# UNITED STATES PATENT AND TRADEMARK OFFICE

## Office Action Summary

10/617,119

## **DETAILED ACTION**

Fig.2

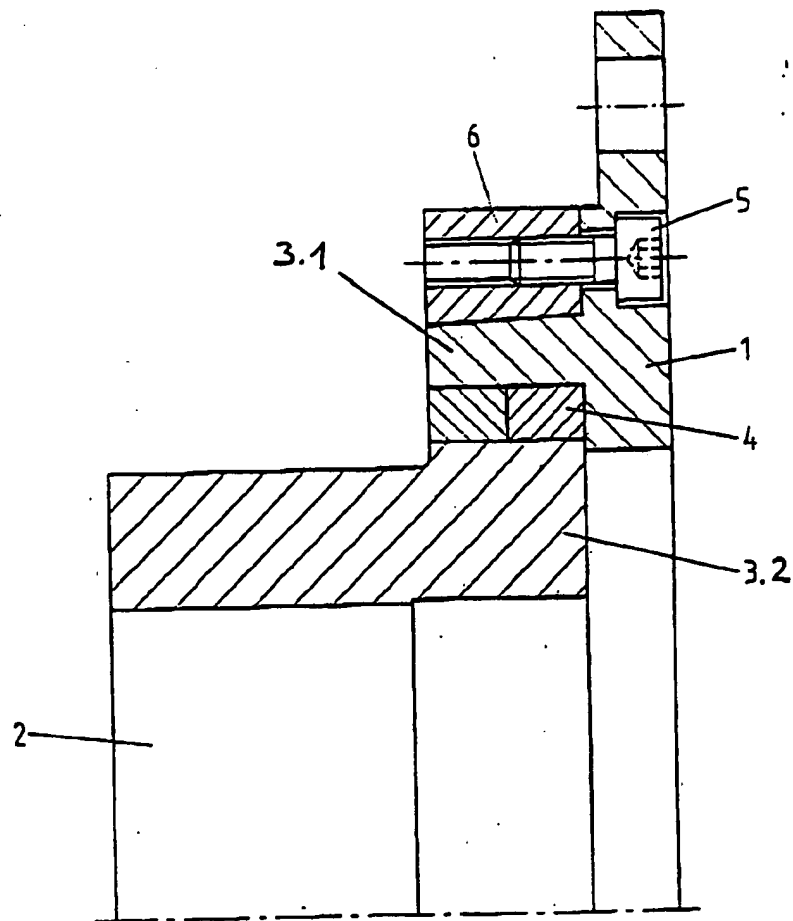
Acceptable  
per  
7/6/05
